# METCALF ENERGY CENTER

RE: Metcalf Energy Center (99-AFC-3): Data Responses, Set 1G and Set 3D

Subject: Metcalf Energy Center Planned Development Rezoning, Prezoning, and  
Annexation (City File Nos. PDC99-08-071 and Riverside No. 49)

PLANNED DEVELOPMENT ZONING FOR  
**METCALF ENERGY CENTER**  
A JOINT DEVELOPMENT OF CALPINE AND BECHTEL  
SAN JOSE, CALIFORNIA  
FEBRUARY 2000  
PDZ No. \_\_\_\_\_

**GENERAL DEVELOPMENT PLAN - EXHIBIT C**  
**LAND USE PLAN**

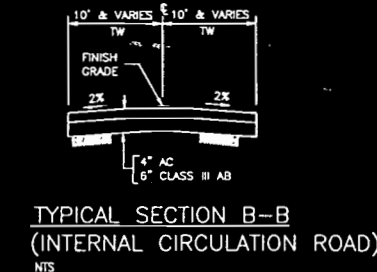
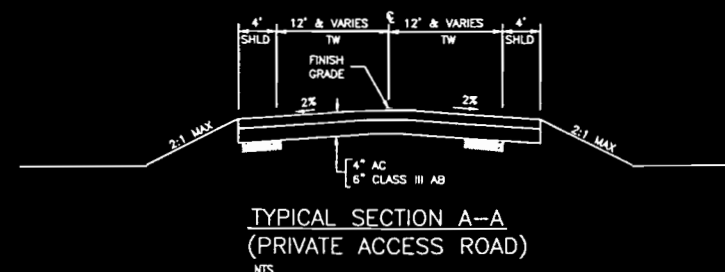
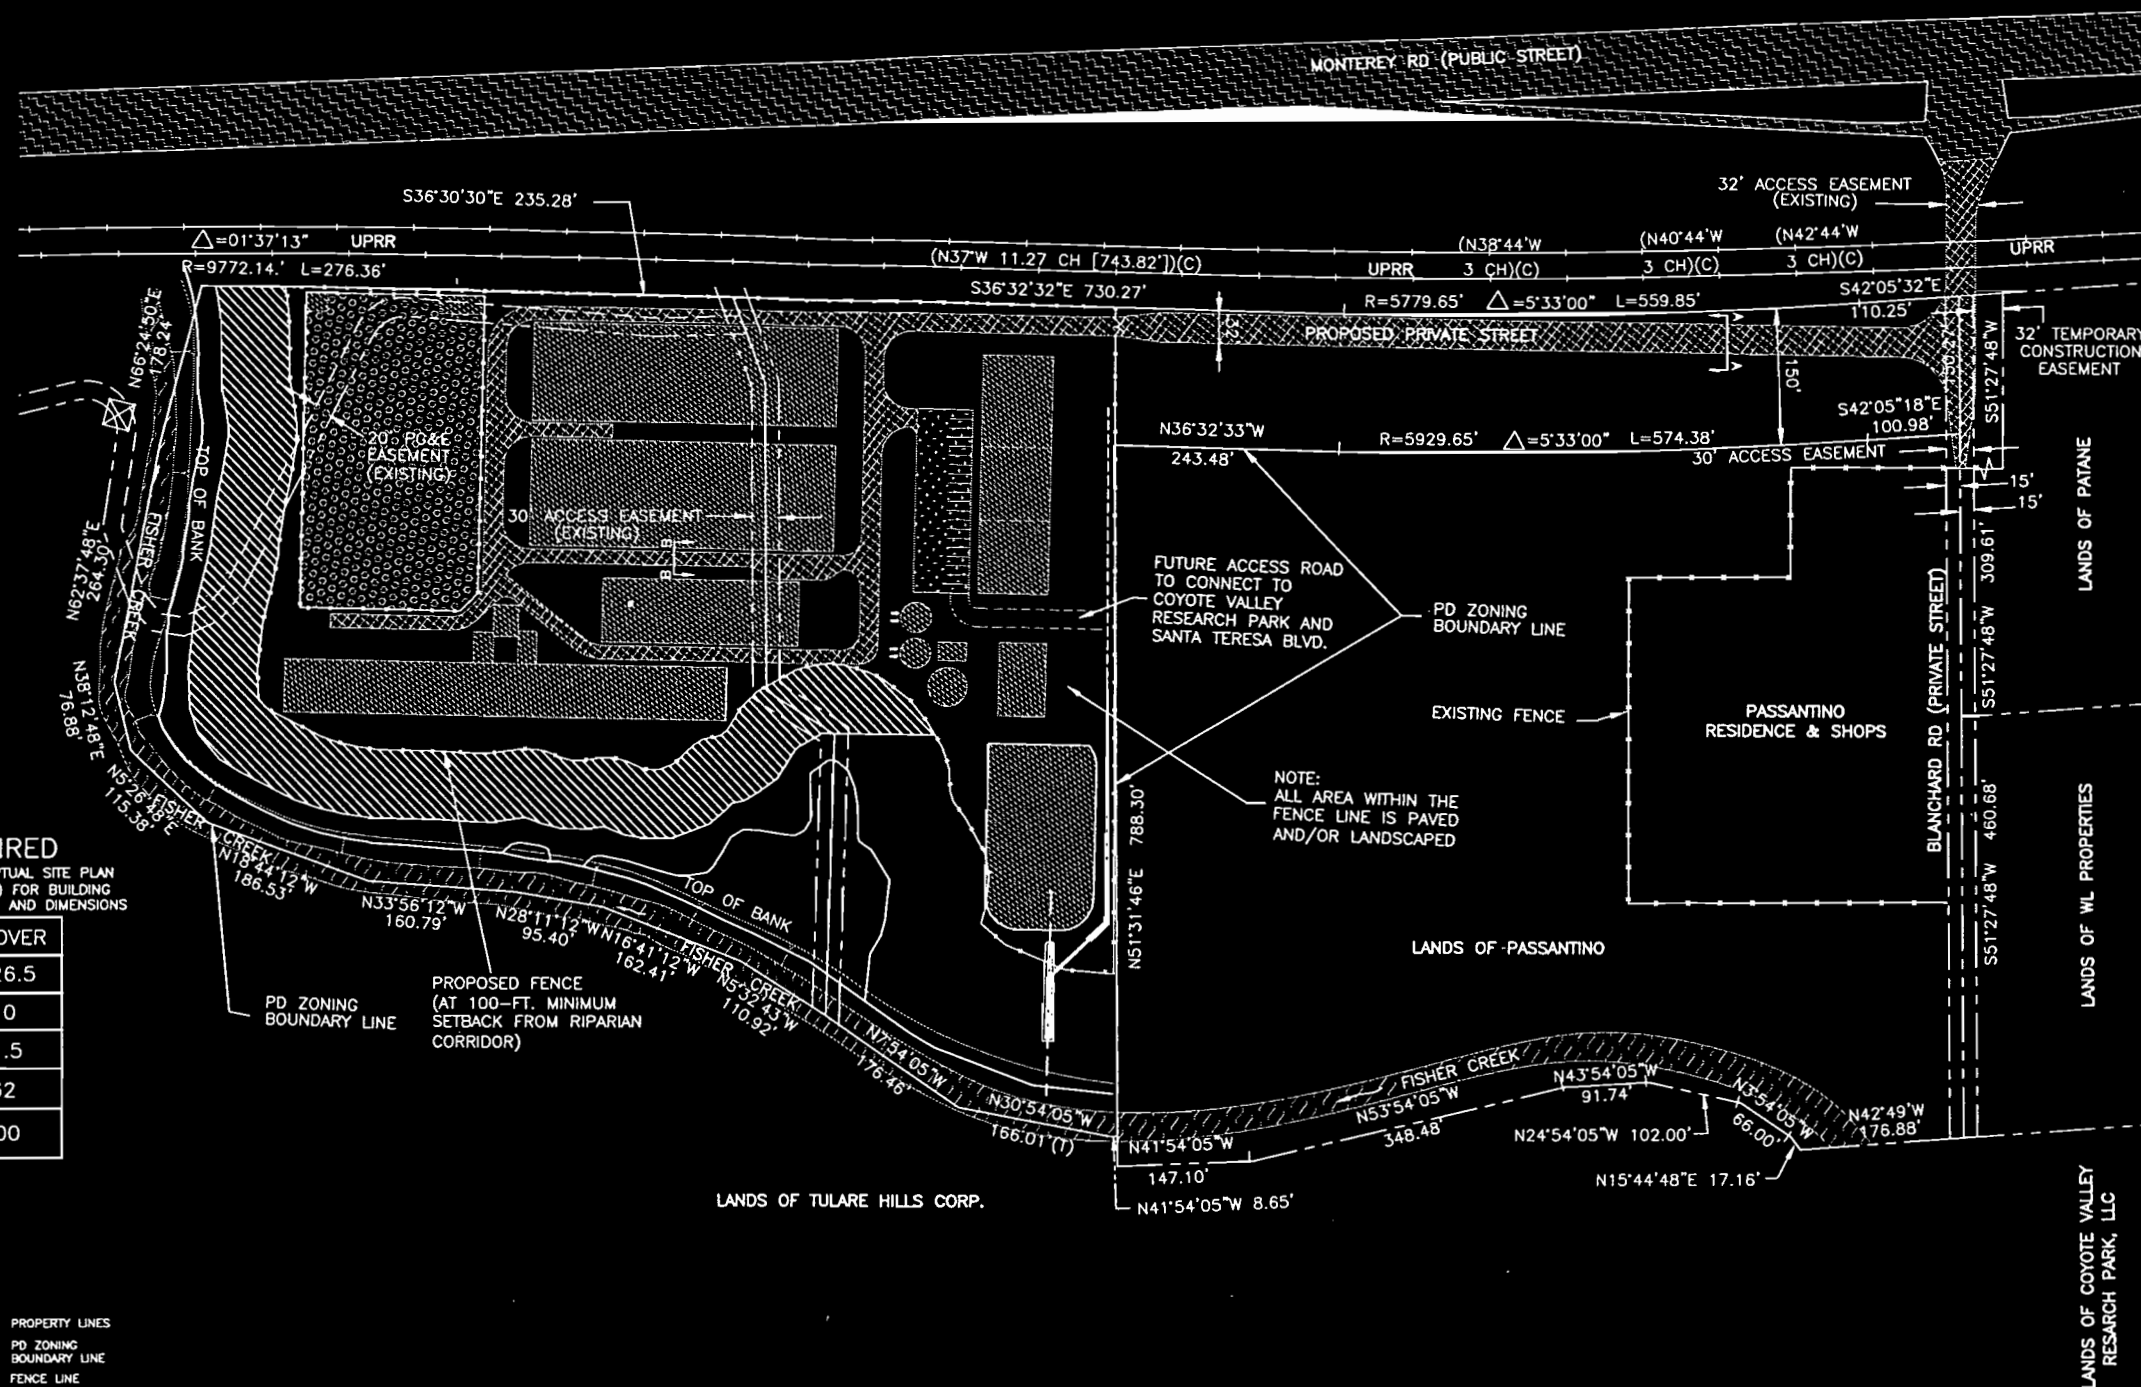
We would appreciate any assistance the City can provide in encouraging the adjacent property owners to work with Calpine/Bechtel, such that the build-out of roadways in the Coyote Valley Research Park (CVRP) area is optimal from the long-term view of the City. At such time as an alternative access to Santa Teresa Boulevard can be obtained, use of the Blanchard Road grade crossing as the primary access to the MEC will be discontinued. However, the residents along Blanchard Road will require ingress/egress via the improved grade crossing until other permanent ingress/egress becomes available to them.

Our proposed Land Use Plan (see Sheet 2) now identifies the possibility of future access to the site via a connection through the CVRP to Santa Teresa Boulevard. In addition, we have included a Master Utilities Plan (see Sheet 11) for the PD Zoning, which indicates the currently proposed locations of domestic water, recycled water, industrial wastewater, and natural gas pipelines. This Sheet also identifies the proposed CVRP circulation plan (as currently contained in the PD Zoning application for that project dated February 4, 2000) on file with the City Planning Department. We request that the PD Zoning for MEC approve both the primary access at the Blanchard Road grade crossing and a possible future access through the CVRP. If CVRP were developed, we would connect to the street system that is built as part of that development, and locate the utilities that would otherwise have gone through farmland within the street system right-of-way. If CVRP were not developed, we would want to build an access road over the water pipeline right-of-way.

GENERAL DEVELOPMENT PLAN - EXHIBIT C  
CONCEPTUAL BUILDING ELEVATION  
SHEET 2 OF 2

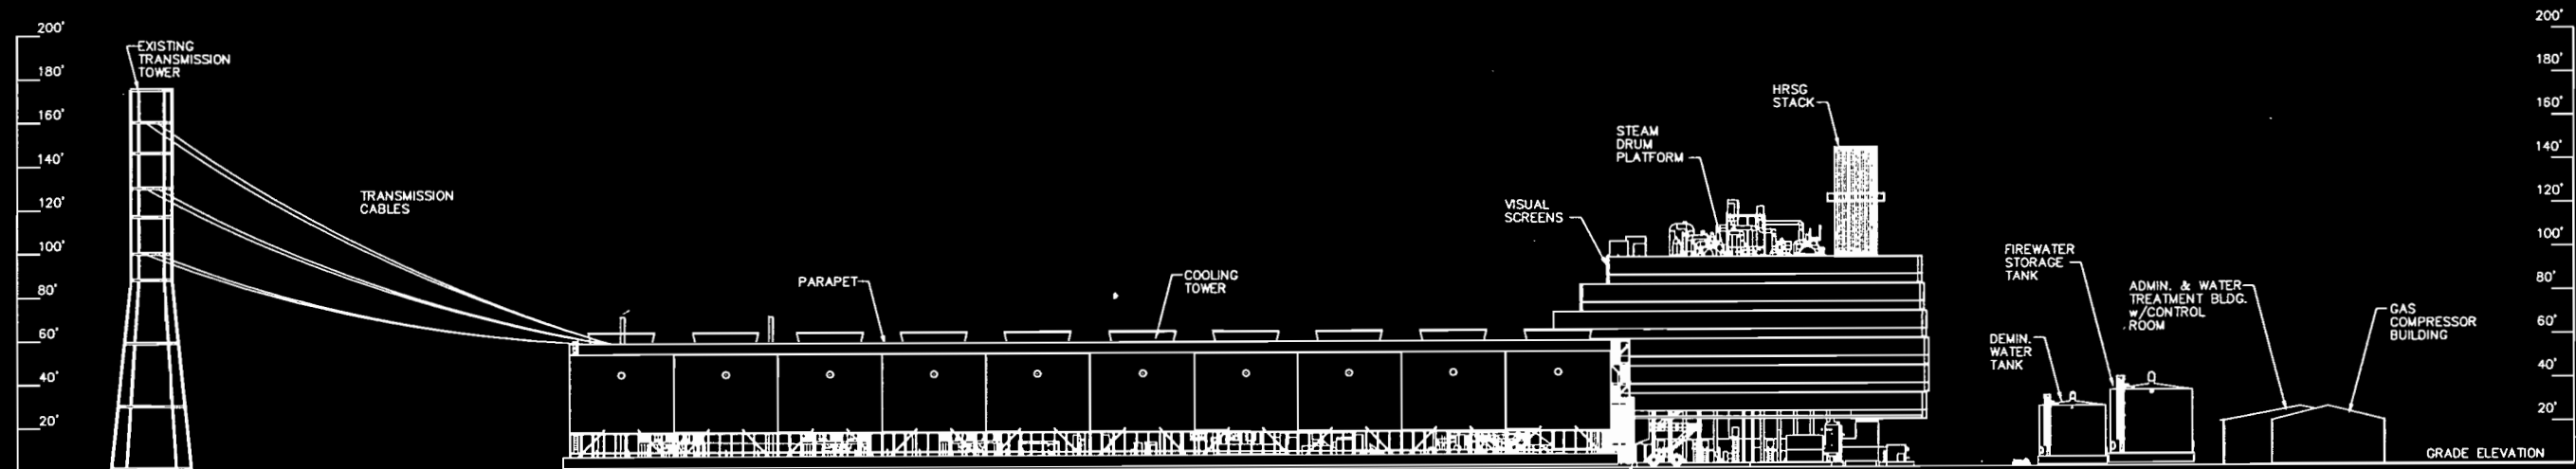
Planning Staff have indicated that the maximum building height allowed under Public/Quasi-Public General Plan designation is 95 feet. The City's General Plan does allow, however, for different height limits to be established in the context of project review for structures other than buildings where substantial height is "intrinsic to the function of the structures" and where such structures are located to avoid significant adverse effects on adjacent properties.

As shown on Sheets 8 and 9 of the attached PD Zoning plan set, all of the buildings on the MEC site meet the 95 feet height limit. Only the Heat Recovery Steam Generator (HRSG) stack, which has a height of 145 feet, and some HRSG external piping, vent silencers and their support structures extend above the City's height limit. For reference purposes, the existing 230 kilovolt PG&E transmission tower located to the north and nearest the site is 174 feet tall above its foundations.

The HRSG stacks are intrinsic to the function of the HRSG. The 145-foot height of the HRSG stacks was determined by air quality modeling as that required to provide for adequate dispersion of plant emissions under all meteorological conditions. Based on the results of the air quality modeling performed for the MEC, the 145-foot stacks will prevent significant local air quality impacts.

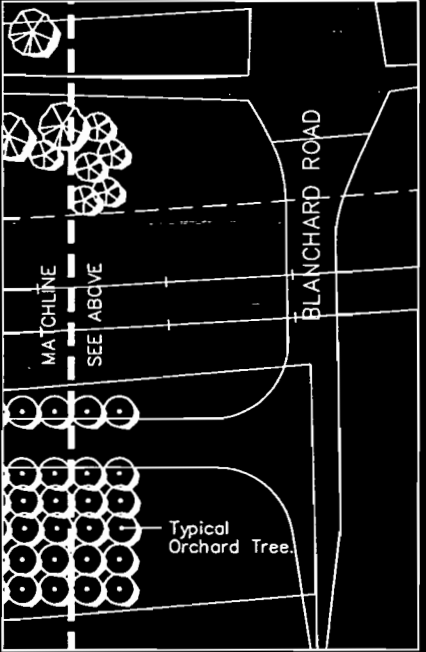
The City has expressed concern about the removal of mature trees to accommodate construction of the MEC. Particular emphasis has been placed on the preservation of any designated heritage trees, Keesling walnuts, oak trees, and trees located within the required riparian corridor setback area. Sheet 4 of the revised PD Zoning submittal shows the revised tree survey and riparian corridor diagram. The table on Sheet 4 shows that there are 161 trees on the site, and that 80 of these will be impacted. None of the riparian species will be affected, and no oak trees or other heritage trees will be removed.

Sheet 10 of the PD Zoning submittal shows the revised landscape plan for the new site layout. As shown on Sheet 10, a significant amount of new landscaping will be added to the site, along with riparian restoration and plantings, and reestablishment of the wetland area northwest of the site. We believe that this plan substantially addresses the City's concern about tree removal.
